City of Enumclaw Pool Evaluation

October, 2017

*Prepared by:
Aquatic Commercial Consulting
Richard A. Young, Aquatic Consultant
408-741-5871 // richy@aquacom.us*

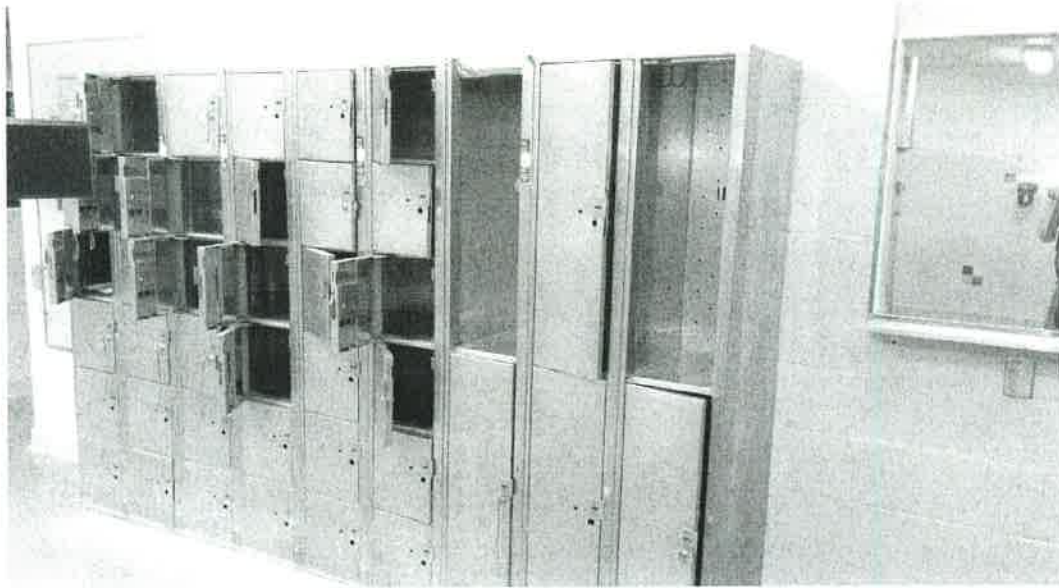
3. The tile and drains immediately around the bases of the shower posts have failed and the drains are loose.

Recommendation: Complete replacement of the missing tile and properly secure the drain with stainless steel screws.

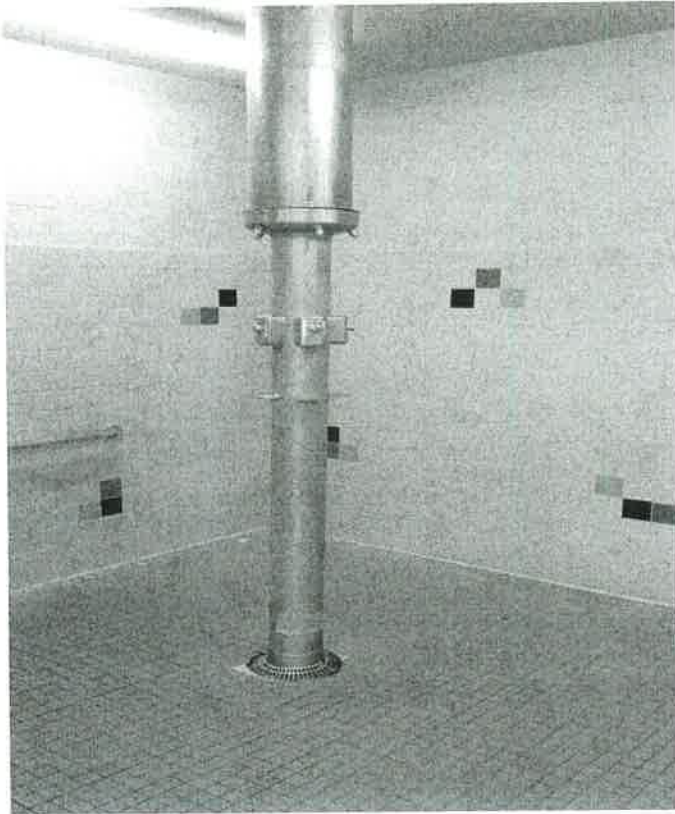
4. The existing stainless steel lockers are of various sizes, in reasonable condition, but are missing many of the locks and several doors. Staff reports new fixtures and doors are being pursued.

Recommendation: These lockers are in good condition but are requiring Replacement locks and several locker doors. Replace the locks and doors as required.

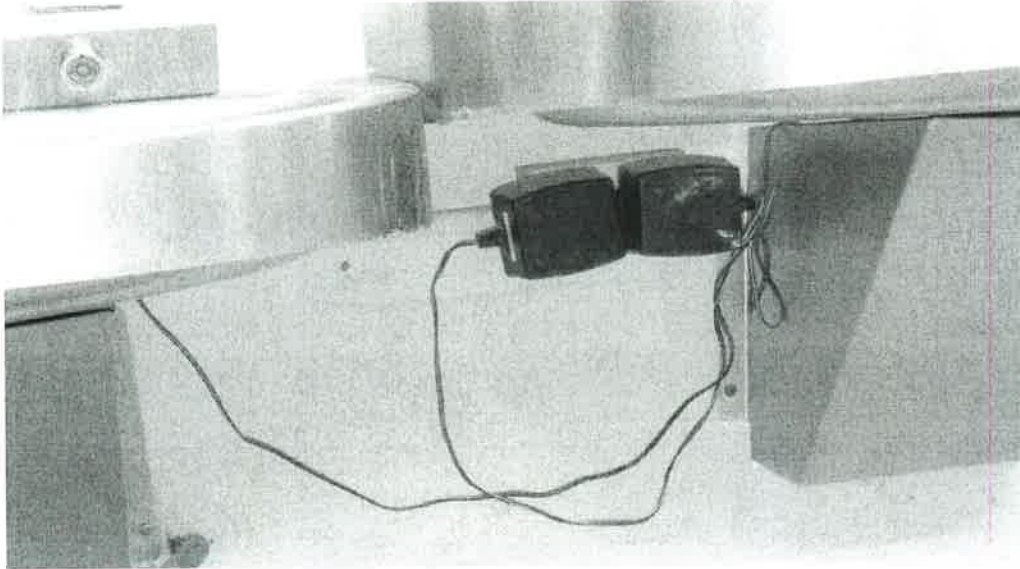
5. There is no compliant ADA shower in the men's locker room, however, staff reports the women's shower area is fitted with a hand held shower and bench. The existing shower handles are too high for wheel chair bound patrons.

Recommendation: Retrofit at least one shower nozzle to a hand held shower head with an operating handle on the flexible head.

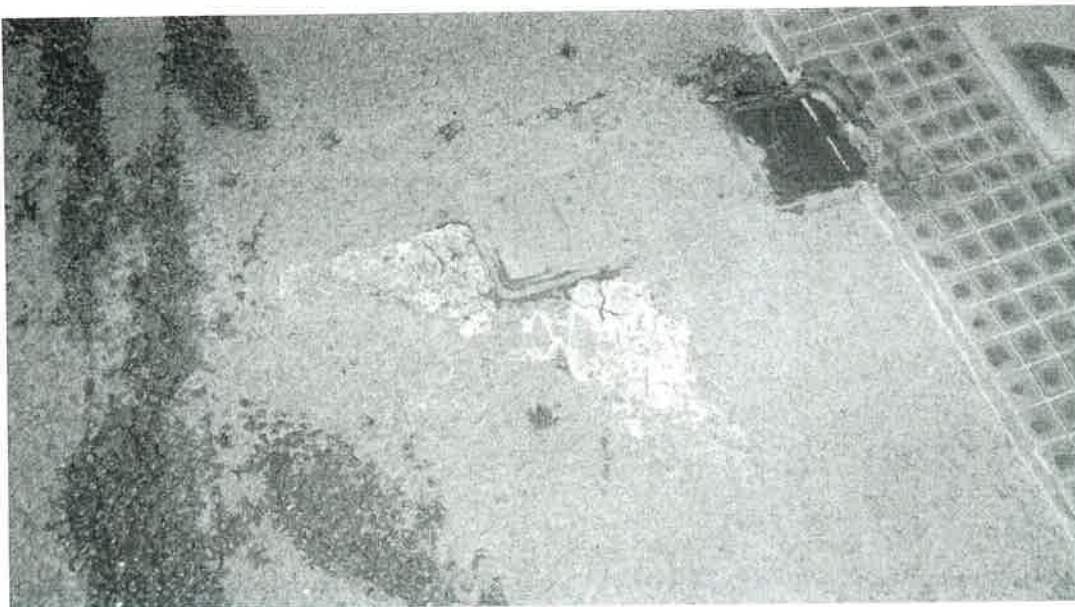
8. There are other non-compliant electrical receptacles that are not GFCI protected.

Install appropriate GFCI receptacles or install a GFCI breaker and appropriately label the receptacle that it is GFCI protected.

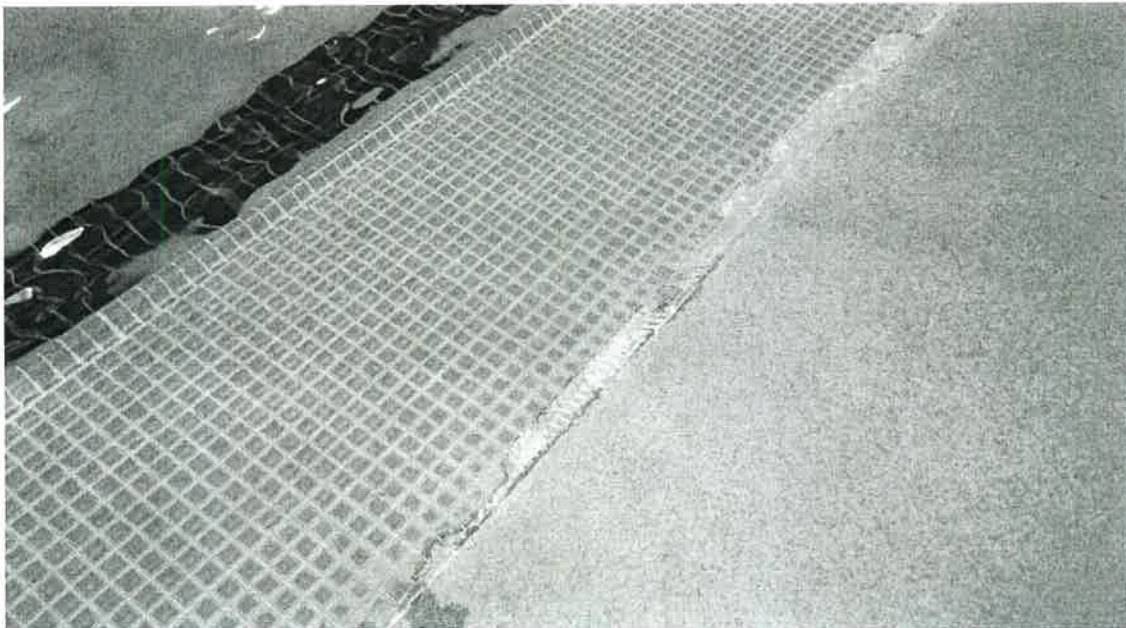
2. Many of the existing deck anchors have been abandoned with many others still in use that do not have covers and present a “toe-stub” hazard. It is worthy to note that the diving platform anchors are still in place in the shallow end. Staff reports they have not been used. Most all swimming sanctioning agencies call for a minimum of 6 feet of water for racing lane dive stands.

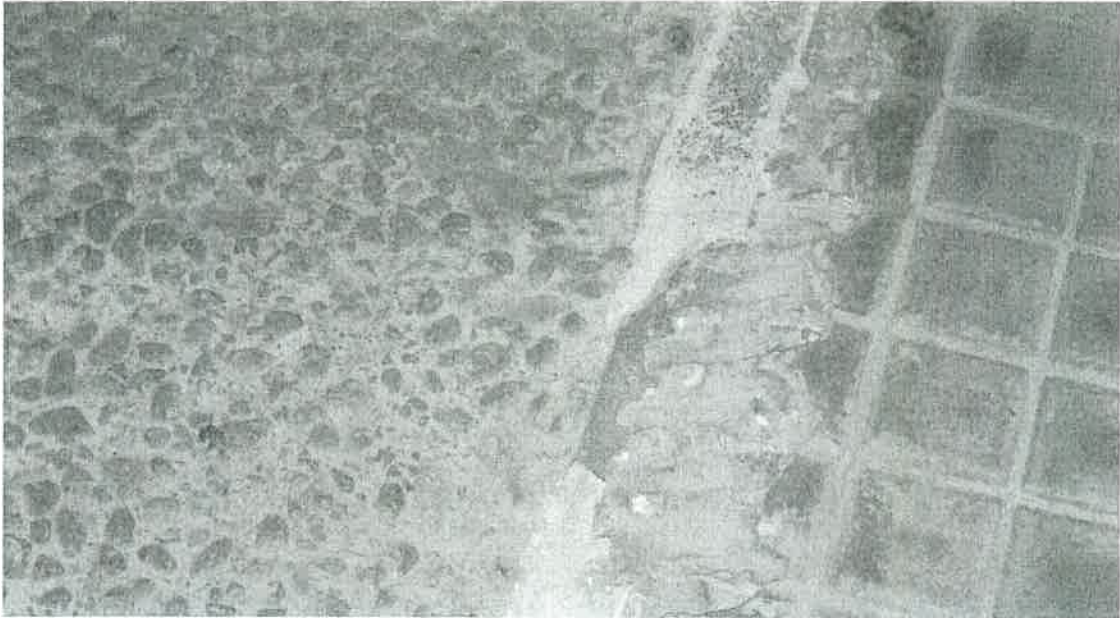
4. Several of the handrails are loose and are not in compliance with WAC and IS.
5. The expansion joint between the tile and the deck is failing in several areas.

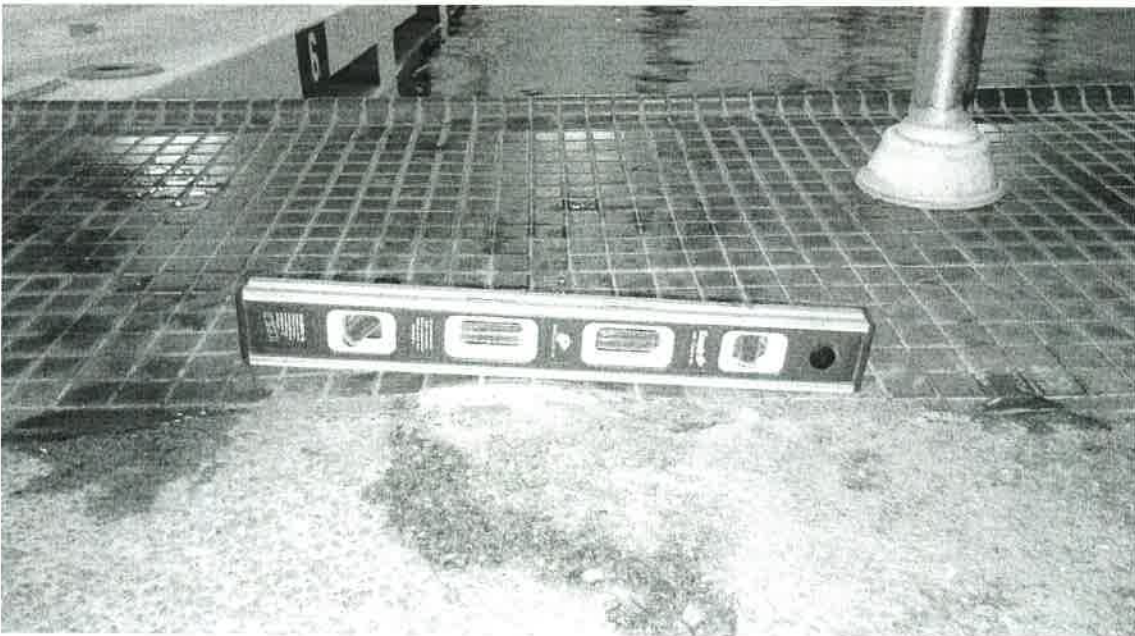
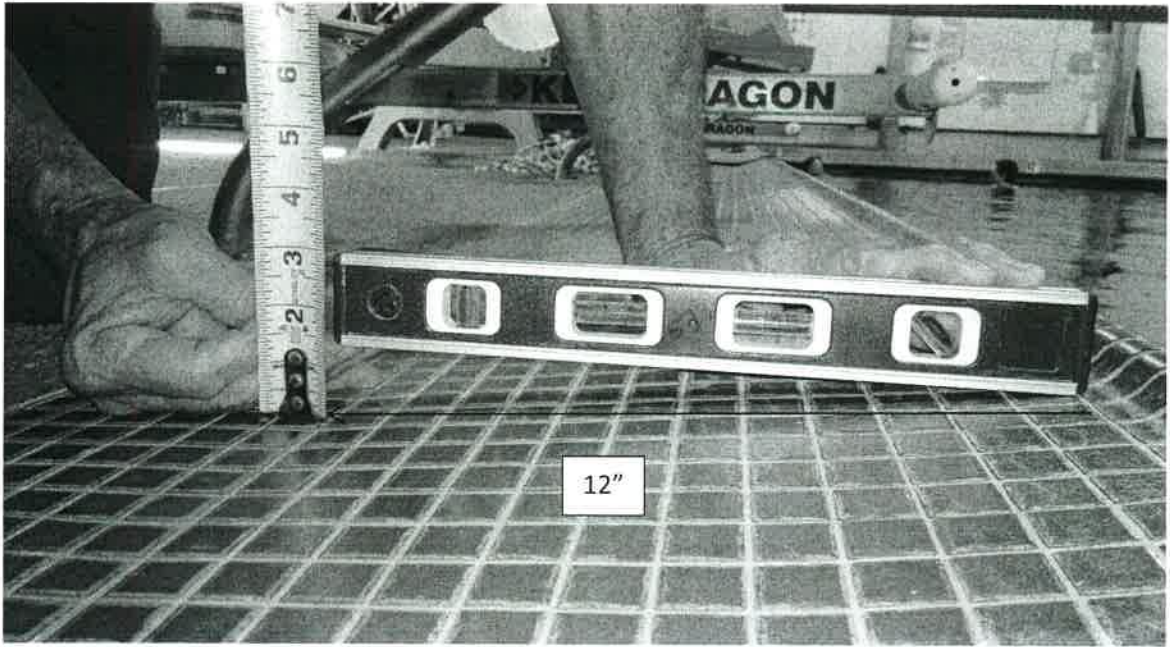
6. Many of the 1" square pool tiles are missing or are cracked around the pool edge.

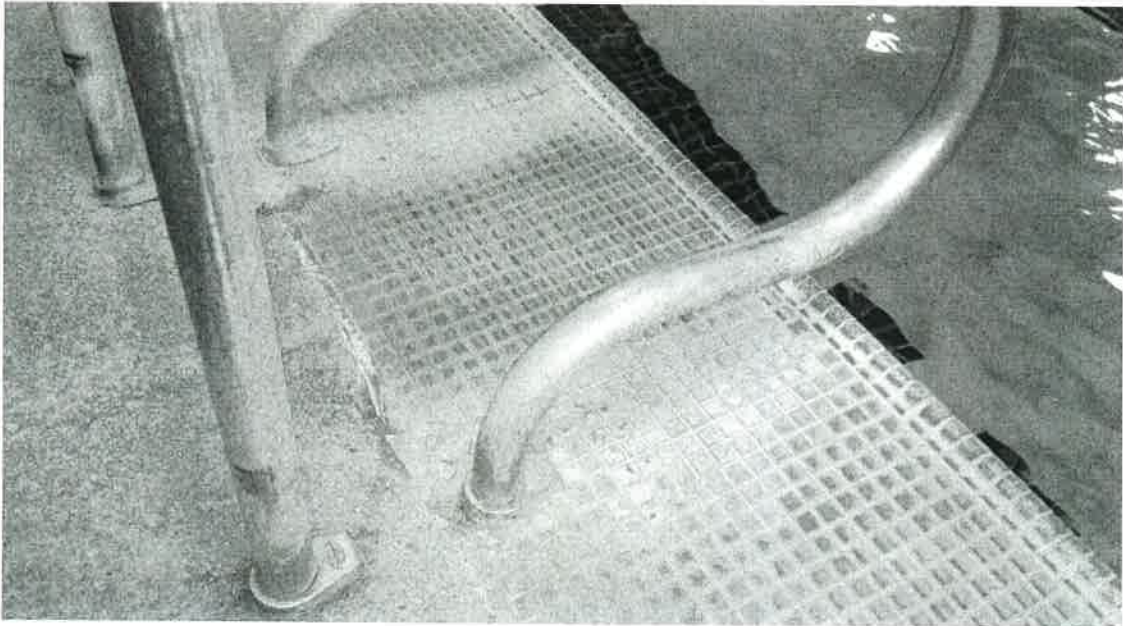
7. The tile edge around the pool has a slope significantly greater than the ADA minimum of $\frac{1}{4}$ " per linear foot and is non-compliant. In some areas the slope is more than 5 times the maximum slope.

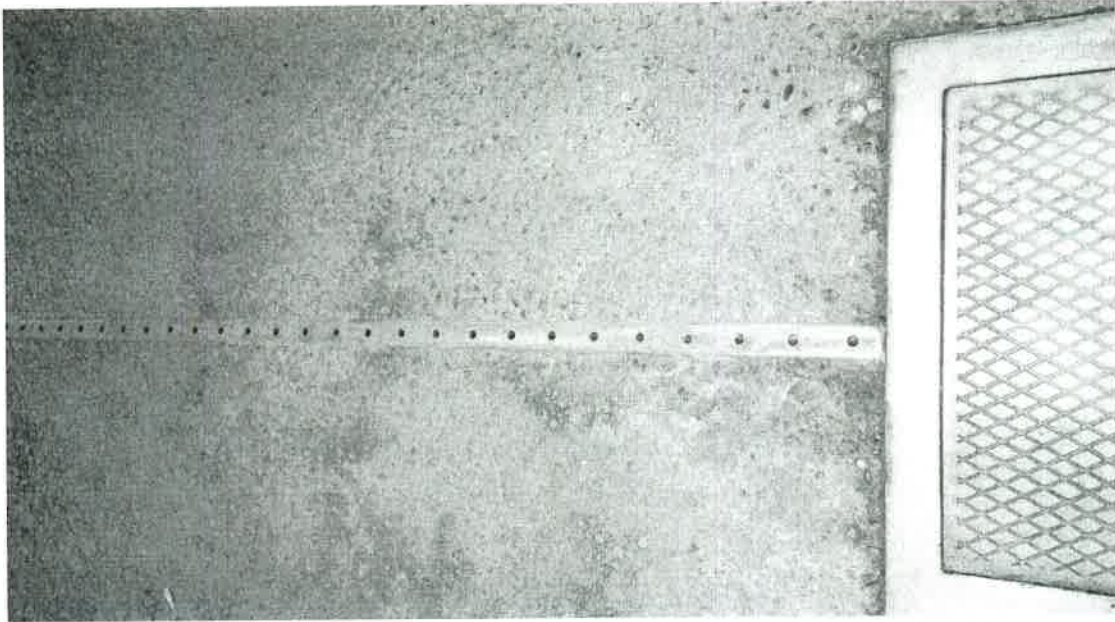
8. Most all of the tile section is well stained with calcium deposits and is unsightly.

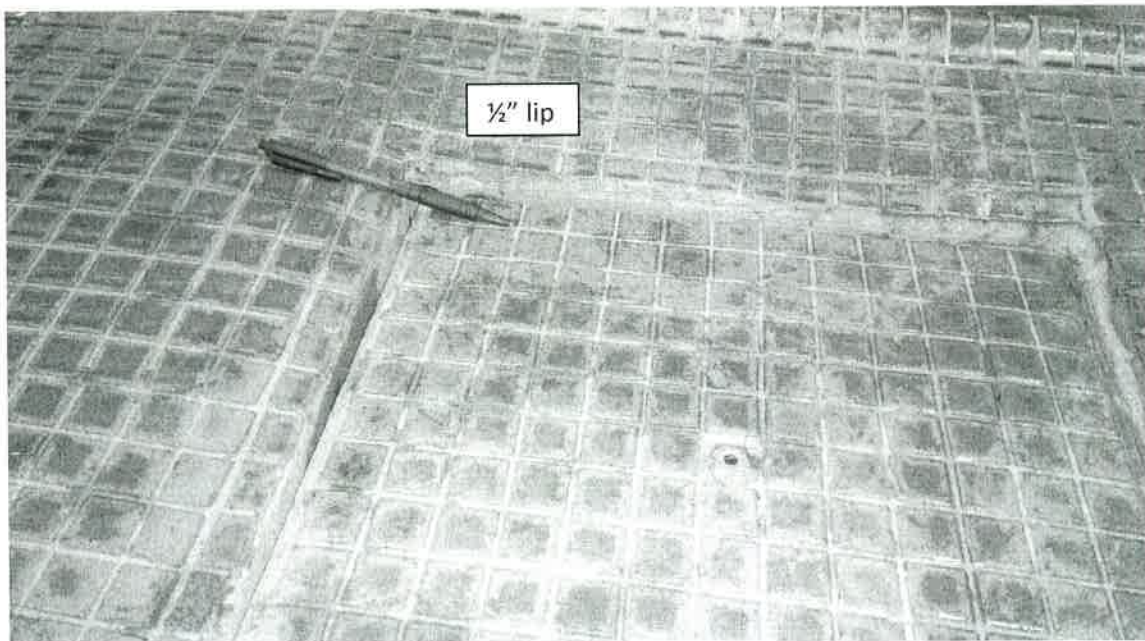
9. The stainless steel deck drain is reported by staff to function adequately for the most part, however, there were areas of standing water and the openings need cleaning.

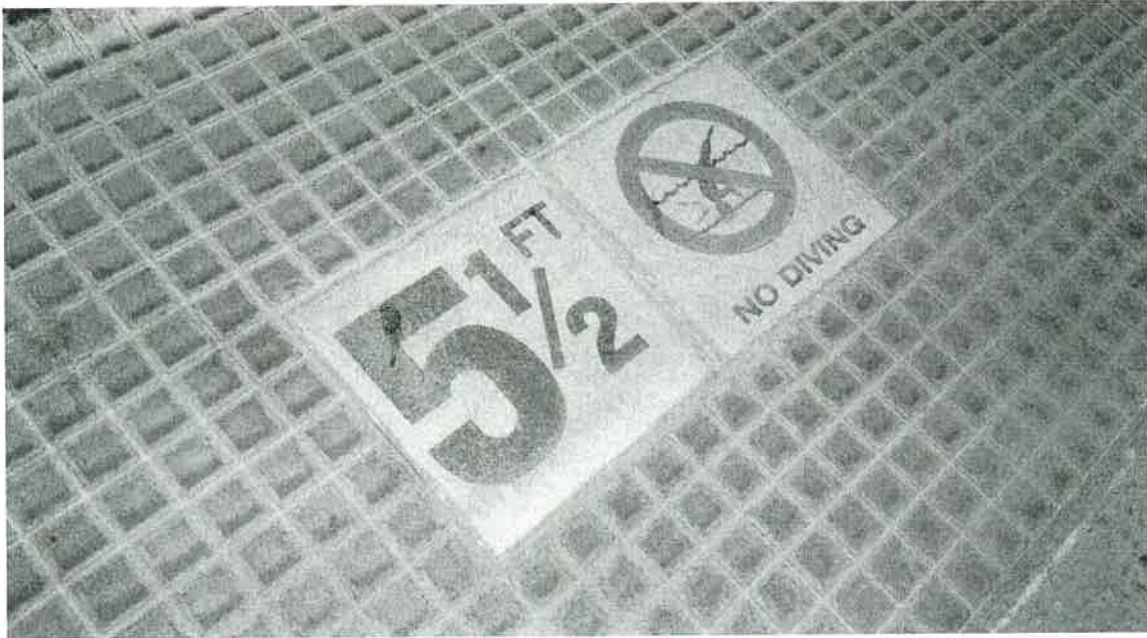
10. The cover over the gutter access port is considerably uneven with the deck and presents a trip hazard.

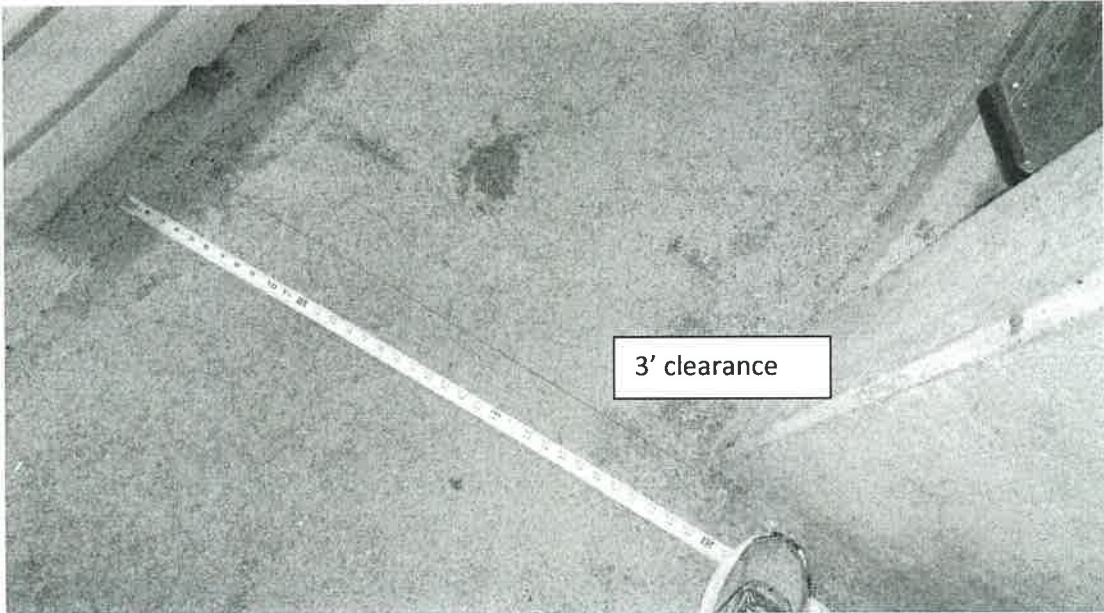
11. Several of the depth and no diving markers are considerably scaled and are unsightly.
